STAFF REPORT

HEARING DATE: January 12, 2021

SUBJECT: H-2020-0083
Southridge South – RZ, PP

LOCATION: South side of W. Overland Rd., east of S. Ten Mile Rd., in the north ½ of Section 23, T.3N., R.1W.)

**Southeridge South Subdivision
Common Driveway Exhibits - Driveway B
Preliminary Plat**

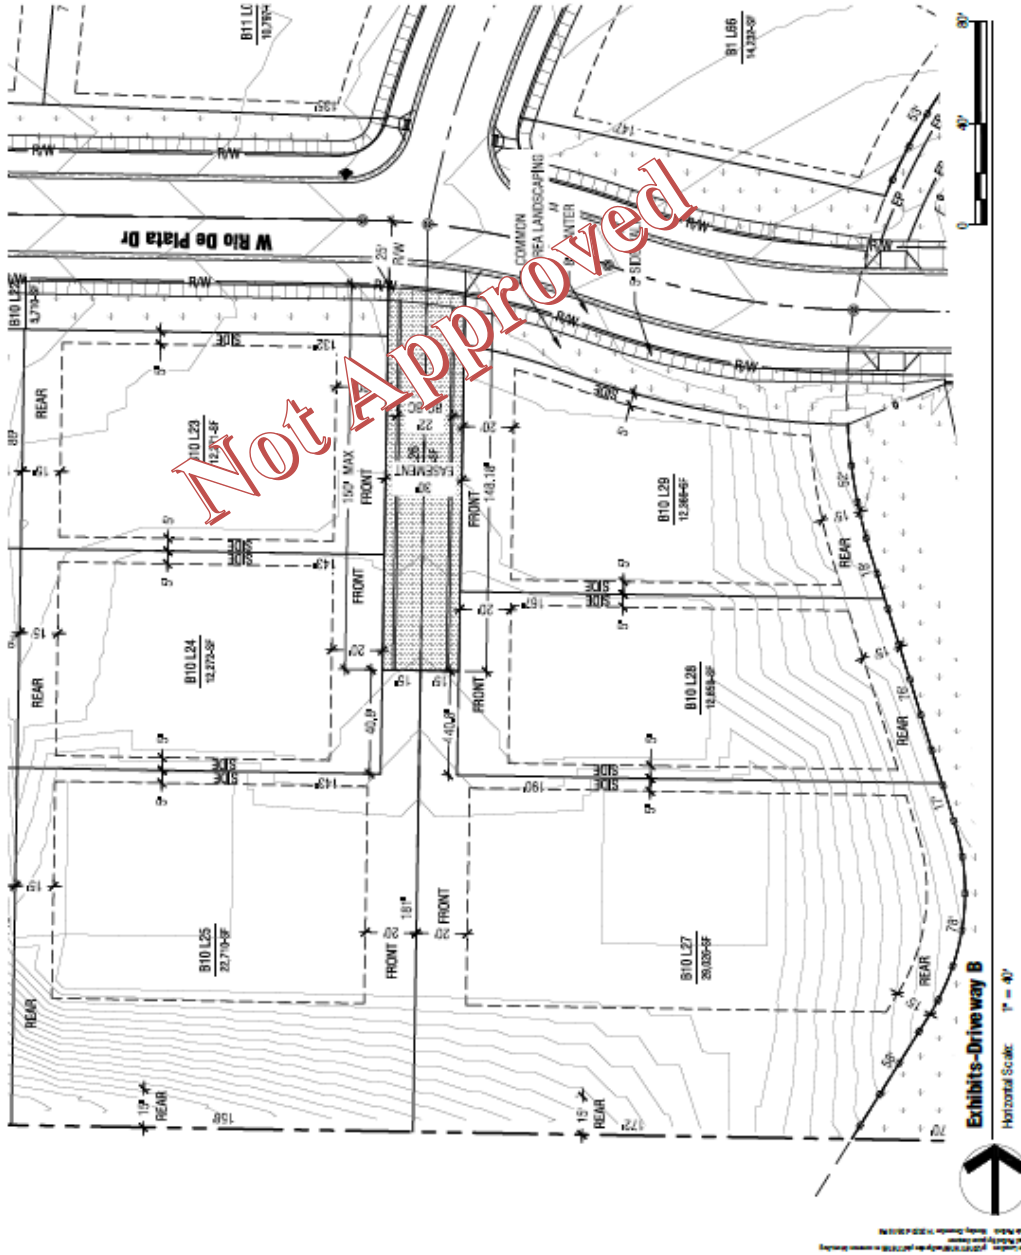
There are three (3) common driveways proposed, depicted as “A”, “B” and “C” on the plat on Lots 18 and 26, Block 19 and Lot 41, Block 1. Such driveways should be constructed in accord with the standards listed in UDC 11-6C-3D. **A common driveway exhibit is included in Section VII.C but is not approved - some revisions are needed to the exhibits in regard to the building envelope/setbacks for homes at the ends of the common driveways (minimum 20’ wide driveway access needs to be provided to all lots outside of the required parking pad area); updated exhibits that demonstrate compliance with the setback, building envelope and lot orientation standards in UDC 11-6C-3D.7 should be submitted prior to or with the final plat application. Because the placement of homes on Lots 17, 19, 25 and 27, Block 10 will likely be beyond the required “hose lay” standards of the Fire Dept., homes on these lots shall be sprinklered, unless otherwise approved by the Fire Marshall.**

C. Common Driveway Exhibits – NOT APPROVED
